Response to the Section 46 Completeness Reports (Vegetation) for the Proposed Nova Energy Solar Farm, Twizel

Contract Report No. 6620d†

Prepared for:	Nova Energy	Reviewed and approved for release by:  Nick Goldwater Senior Principal Ecologist
Author:	Roland Payne	
Report No:	6620d-i	
Date:	September 2026

GPS Track logs

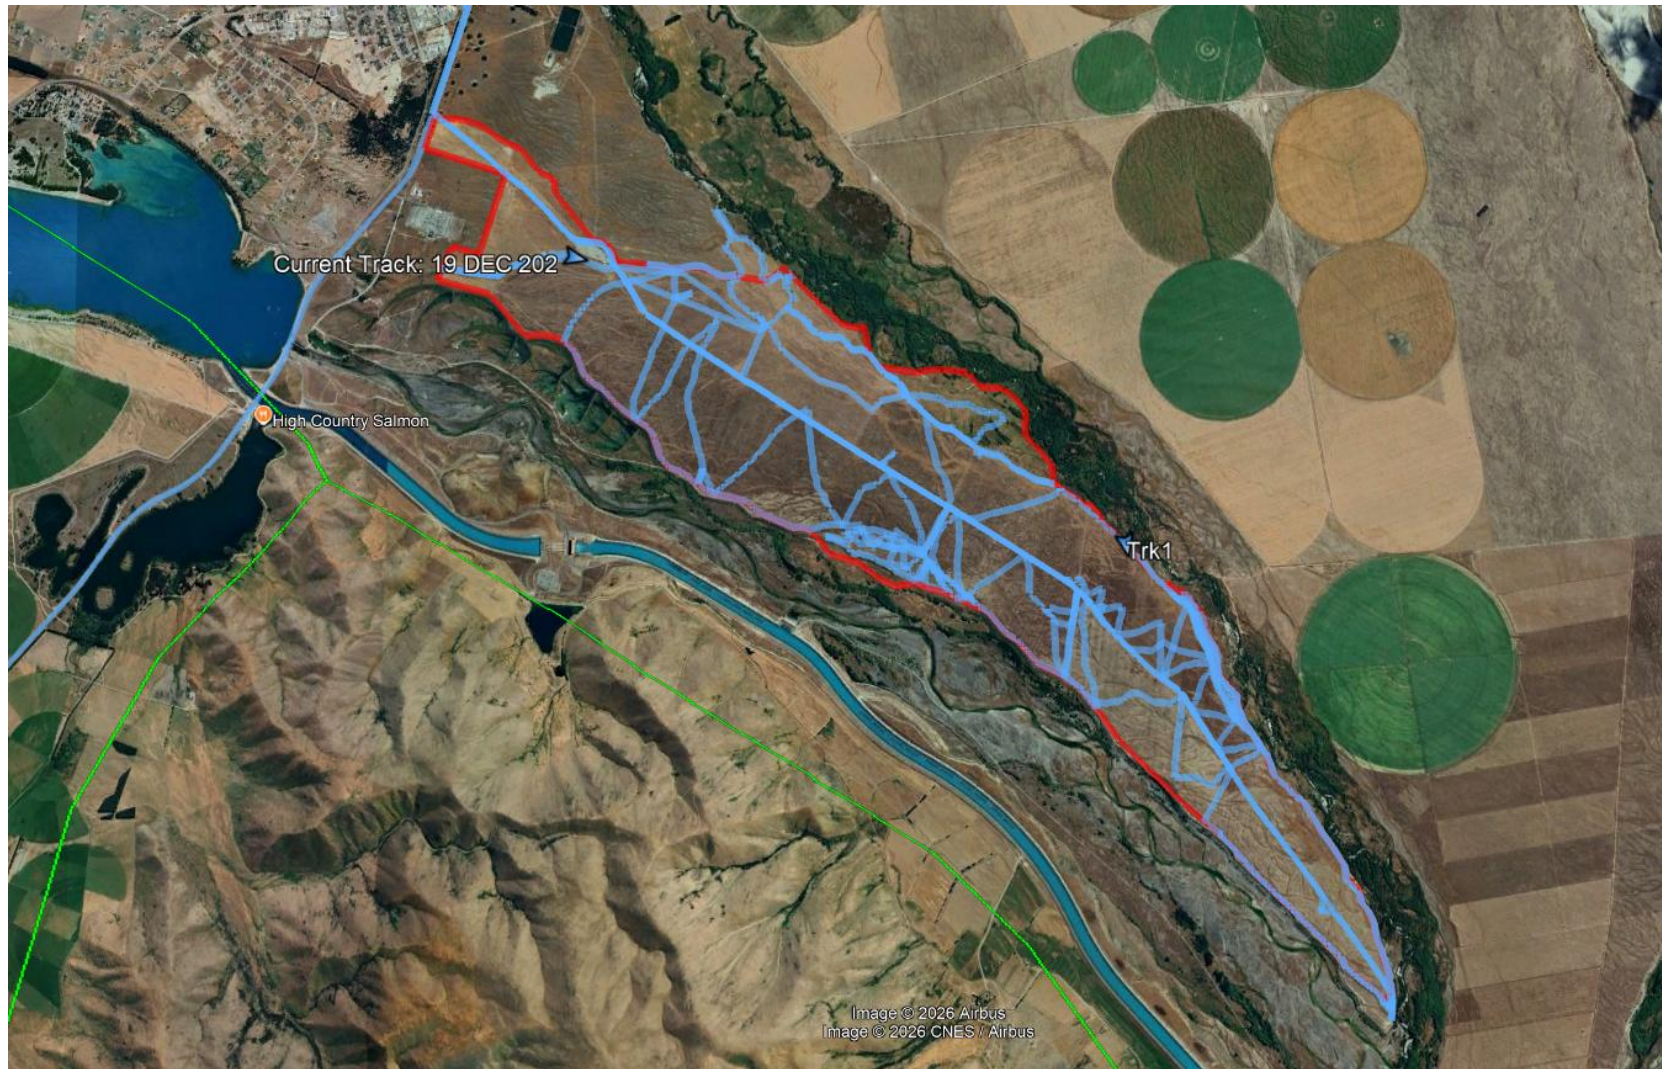
CRC comments: Vegetation – the survey effort or coverage is not well described by the AEE. No track log is provided, no plot-based surveys/recce plots appear to have been used, nor any surveys conducted in spring to identify spring-annuals. Potential data deficiencies. What additional species may occur at this site? Could *Lepidium solandri* occur within proposed disturbance footprints?

The recent AEE provides further details explaining how the wider area was searched with a zigzag search pattern. No track log of survey effort was provided, so presumably not recorded. Would plot based recce method provide further information? And consider if Spring annuals were potentially missed due to survey timing (Dec-Jan) – although I note some orchids were recorded.

Although a track log was not provided in the AEE, this data was largely recorded and is presented in Appendix 1.

Track logs (blue lines) of vegetation surveys undertaken in 2022 and 2024. The track log of the 2024 survey is incomplete (one day of survey data is missing). During this day (where the tracklog is missing) the southeastern tip of the site and other gaps were traversed in a similar crisscross pattern. The red line indicates the Nova site boundary.
